**The Light
company**

October 31, 1985
 ST-HL-AE-1499
 File No.: G9.17

South Texas Project
 Units 1 and 2
 Docket Nos. STN 50-498, STN 50-499
 Responses to DSER/FSAR Items
Geology

The attachments provide STP's response to Draft Safety Evaluation Report (DSER) or Final Safety Analysis Report (FSAR) items.

FIGURE 1

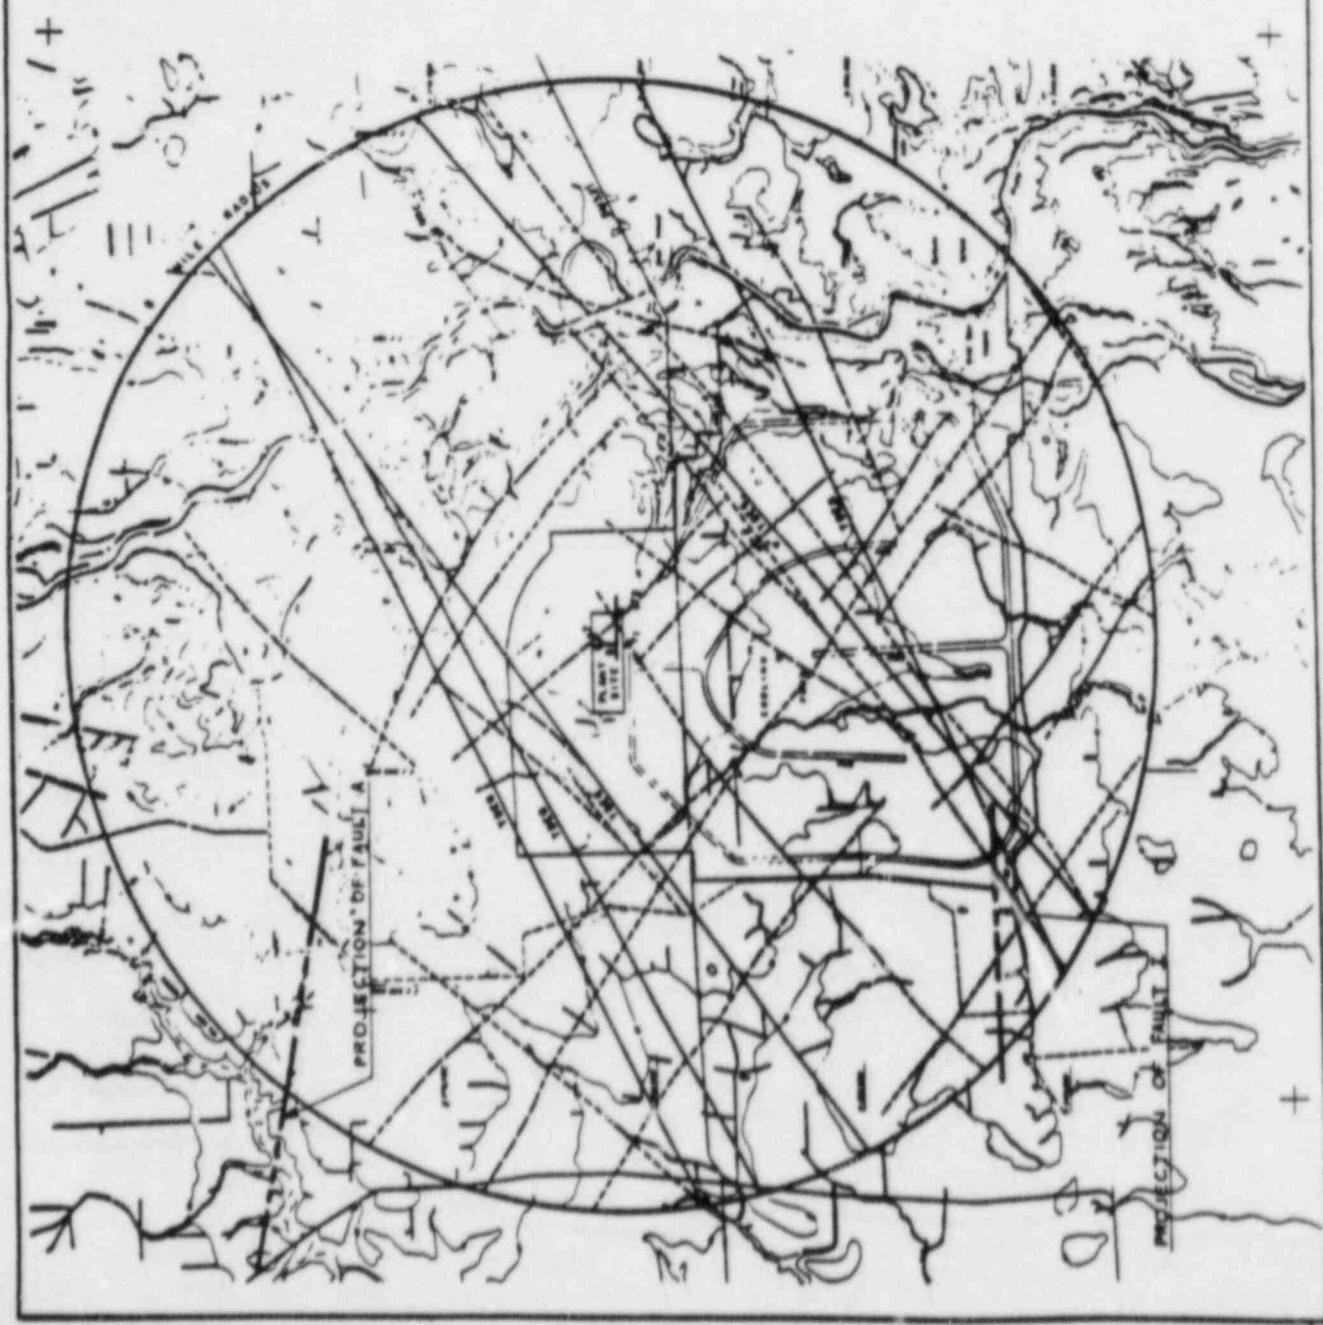
The surface projections of both features, A and I, have been compared to the results of the CP lineament study (Figure 1) and the 1985 lineament study (Figure 2). None of the lineaments identified in either study coincides with or closely parallels the surface projection of either growth fault.

2.5.1.2.5.6 Postulated Surface Projection of Growth Faults Identified in Upper 1000 ft - The review of geophysical data (reflection lines and electrical logs) has identified two growth faults which offset sediments within the upper 1000 ft of the ground surface. Fault A, which is located north of the Plant Site, is identified on GUS reflection line A up to a depth of about 440 ft below ground surface. A projection of this plane to the surface forms a trace approximately three miles north of the Plant Site. Fault I is identified on Jaecon reflection line 2M up to a depth of about 800 ft below ground surface. A projection of this plane to the ground surface forms a trace approximately four miles south-southwest of the Plant Site. ~~Therefore~~ Both projected traces have been reviewed using remote sensing imagery and field inspection of the area of projection.

Post-CP review of geophysical data, incorporating more recent seismic lines, has resulted in a slightly different alignment of the major growth fault north of the Plant Site (Fault A) than shown in the CP studies; however, the projected trace of the realignment is within the area investigated in previous work, and observations and conclusions regarding surface evidence remain applicable. (Fault I is based on review of post-CP data.)

FIGURE 2.5.1-15

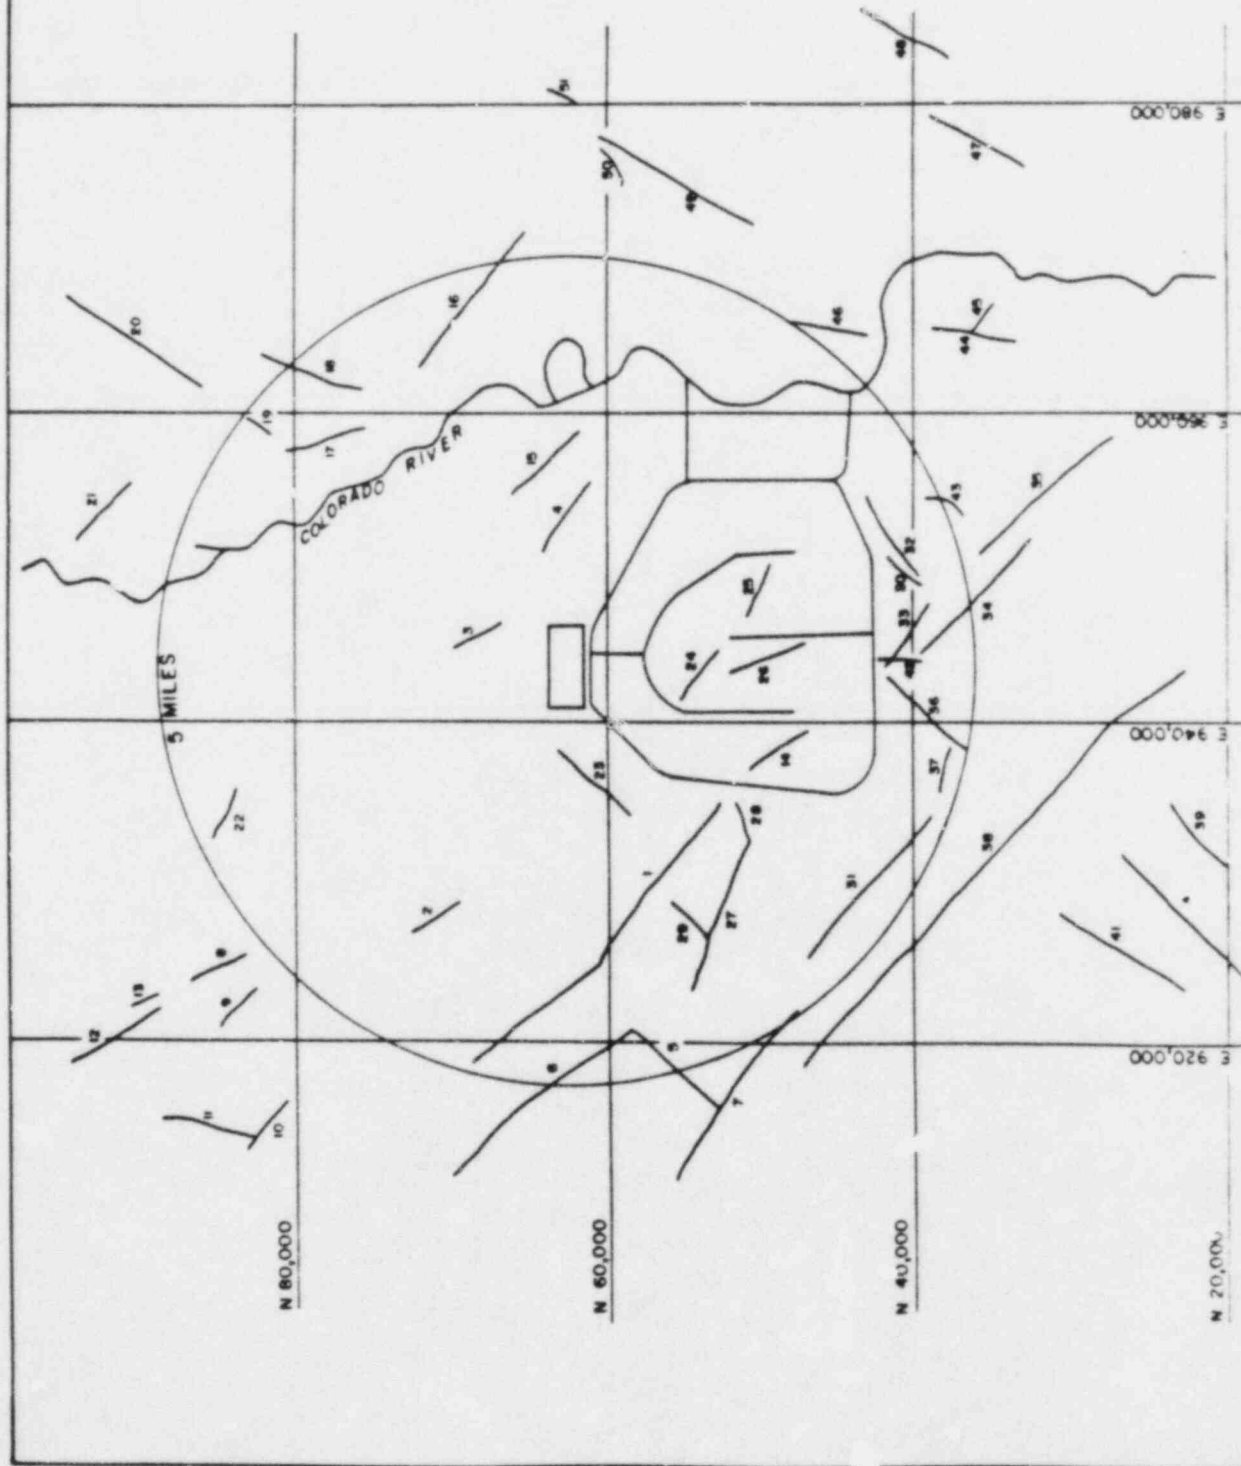
Using guidance contained in the Standard Review Plan conduct a lineament analysis of an area within at least five miles of the site using imagery derived from Landsat, Skylab and other appropriate sources not included in the PSAR lineament study (PSAR Figure 2.5.1-44). In addition to identification, discuss the possible origin and address the safety significance of any lineament which may be structurally controlled. Conduct field truth investigations as required. As indicated by the Standard Review Plan, provide the staff with a copy of the imagery used in your analysis.

Section 2.5.1.2.5.5 has been revised to incorporate the results of a lineament study conducted Summer, 1985, using post CP imagery. Lineaments identified during this study were reviewed using field checks and comparison with other project data. None of the lineaments identified are correlated with geological structure. Section 2.5.1.2.5.5 describes the scope of the study and provides a location map (Figure 2.5.1-15) of the lineaments.

The 1985 lineament study was performed as a confirmatory review to supplement the extensive CP multi-spectral study. The present study used NASA U-2 false-color infrared imagery flown in 1979, based on the evaluation that these data provide the best overview of the five-mile radius study area. Other post-CP imagery was identified. Several Landsat Multispectral Scanner scenes obtained subsequent to 1975 are available (February, 1976; December, 1976, October 1980; and April 1984, with site area at edge); however, as in the CP study (refer to PSAR Figures 2.5.1-44 and 2.5.1-44A) this imagery was not considered to be appropriate to review within the
